UNITED STATES PATENT AND TRADEMARK OFFICE

APPLICATION NO.	FILING DATE	FIRST NAMED INVENTOR	ATTORNEY DOCKET NO.	CONFIRMATION NO.
10/568,571	02/16/2006	Yutaka Akahori	9319A-001559/US/NP	6474
27572	7590	05/08/2009	EXAMINER	
HARNESS, DICKEY & PIERCE, P.L.C. P.O. BOX 828 BLOOMFIELD HILLS, MI 48303			COMLEY, ALEXANDER BRYANT	
		ART UNIT	PAPER NUMBER	
		3746		
		MAIL DATE	DELIVERY MODE	
		05/08/2009	PAPER

Office Action Summary	Application No.	Applicant(s)	
	10/568,571	AKAHORI, YUTAKA	
	Examiner	Art Unit	
	ALEXANDER B. COMLEY	3746

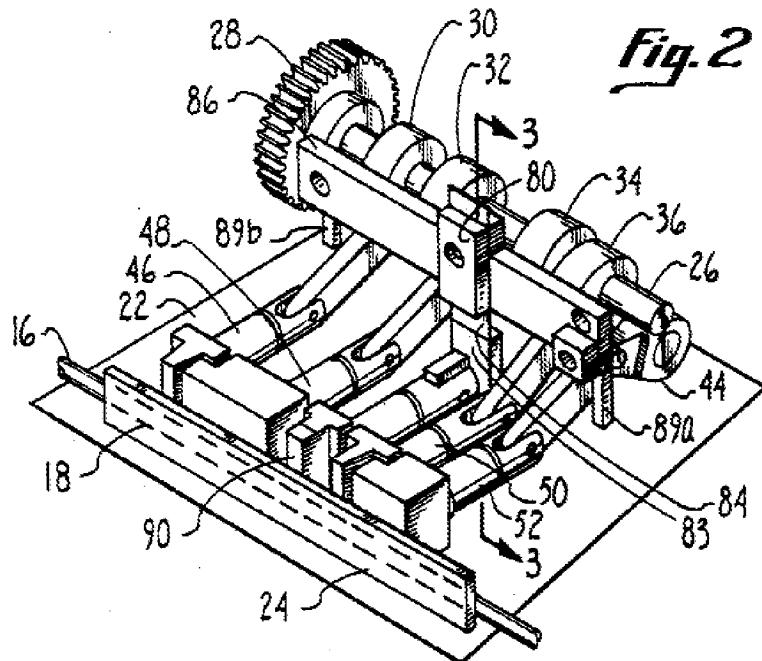
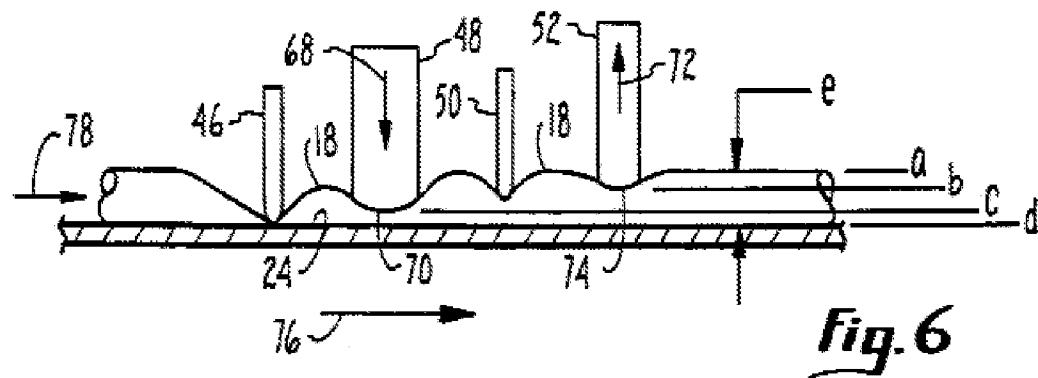
In regards to Independent **Claim 1**, and with particular reference to Figures 2 & 6 shown immediately above, Hyman et al. (5,217,355) discloses:

As best shown in Figure 2 above, Hyman discloses a peristaltic pumping device that is utilized for precisely metering the flow of medical fluids to a patient. The tube has various “curved portions” spaced along it's length (the basic physical cross-section of the tube is round, or curved), and the closing mechanisms are disposed therebetween. Hyman's pump utilizes different sized reciprocating fingers (48, 52) in order to maintain increased internal pressure within the tube. The fingers are reciprocated by a rotating camshaft with four individual cams corresponding to the four individual fingers. In particular, Hyman states “Each cam 30, 32, 34 and 36 contacts a corresponding linkage. Only linkage 44, which is associated with cam 36, is shown in FIG. 2. The cams 30, 32, 34 and 36 against the respective linkages and thereby drive pump fingers 46,

48, 50, and 52 respectively." (Column 4, Lines 55-62) As best seen in Figure 6 above, the pumping fingers (48, 52) are sized differently from one another in order to pump different amounts of fluid through the tube, and consequently, provide increased pressure therein. In particular, Hyman states "With respect to the description of the invention herein, "large" and "small" describe pumping fingers which are constructed to move against tube portion 18 such that the amount of fluid displaced as "large" finger 48 moves downward against tube 18, is approximately two (2) times that displaced by an equal reciprocal downward motion of "small" finger 52. It is important to note that the reciprocal motion of fingers 48 and 52 is generally equal in range, but that in the fully extended position, the pumping fingers 48, 52 do not ever fully occlude the tubing."

would function as Applicant's "push portions", while the outside edges of these "push portions" are where the tubing is "folded" rather than "pushed", thereby functioning as Applicant's "opening/closing portions". And finally, it is clear from Figures 2 and 6 that the mechanisms 48 and 52 are of different sizes in order to generate the increased internal pressure within the tube (See Column 5, Lines 58-68)

6. In regards to dependent **Claim 4**, Figure 2 best shows how the curved portions of the tube are folded through the pushing of the pumping fingers (48, 52) by their corresponding cam portions (32, 36). Regarding dependent **Claims 5-6**, the fingers (46, 48, 50, 52) and the cams (30, 32, 34, 36) form the cam mechanisms that each press against the tube and force fluid therethrough. The fingers (48, 52), as seen in Figure 6, are sized differently from one another in order to provide increased fluid flow while the cams (30, 32, 34, 36), as also seen in Figure 2, are semi-circular in shape. In regards to dependent **Claims 7-10 & 18**, the fingers/linkages of each cam mechanism are disposed on a base plate 22 and form a reciprocating frame that is driven by the cams (30, 32, 34, 36). As the cams are rotated, the frames are reciprocated toward and away from the tubing by the action of the rise and dwell of the cams, as well as the resilient action of the tube itself. The cams' dwell portions each serve to help bias the frame away from the tubing and release the fold applied thereto. In such a linkage, the fingers act as the direct connection between the tube closing portions and the frame. Regarding dependent **Claims 11-13 & 19-20**, Figures 2 best shows that the pump of Hyman utilizes a platen (i.e. fixing jig) to position the tube upon the base. In particular,

Claims 16-17, Applicant's "stepped cam" is taught by Hyman's cam/linkage/finger mechanism (See Figure 2). In particular, Hyman's mechanism comprises four separate semicircular cams (i.e. cam portions) that actuate linkages (i.e. arms) in order to reciprocate differently sized fingers (i.e. actuators). The outer peripheral surfaces of each cam rotates to convert rotational motion into linear reciprocating motion in order to bring each of the linkages (i.e. arms) and fingers (i.e. actuators) into physical contact with the opening/closing portions of the tube. Hyman states "Mounted on base 22 is a rotatable shaft 26, which is driven by a motor (not shown) that engages with gear 28. Shaft 26 also includes cams 30, 32, 34 and, 36. Each cam 30, 32, 34 and 36 contacts a

8. In regards to Applicant's argument that Hyman's pump doesn't fold the tube by pushing another portion of the tube, the Examiner must respectfully disagree. As shown in the figures above, the two "pumping fingers" 48 and 52 are large, wide fingers that reciprocate up and down in order to squeeze the tube, but not fully occlude it (See Col. 5, Lines 49-53) However, the two "pinching fingers" 46 and 50 do, in fact, completely occlude the tube, and reciprocate in phase with the two pumping fingers in order to provide increased internal pressure within the tube and provide efficient pumping action (See Col. 5, Lines 12-48). These pinching fingers, therefore, fold the flow path to close it at a position away from the pushing (i.e. opening/closing) portions.
